## PT 5210 VARiTIME DIGITAL SYNC GENERATOR

## PT8603 SDI TEST SIGNAL GENERATOR

Supplement to: PT 5210

The supplement describes the modifications made to the standard instrument.

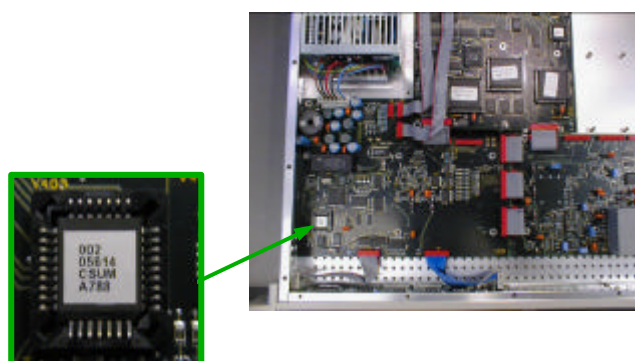
Software in the PT5210 has been modified to allow for moving text feature in PT8603

The text menu contains now “Text ON/OFF” only. The remote interface commands are unchanged.

Master software version is 3.7.
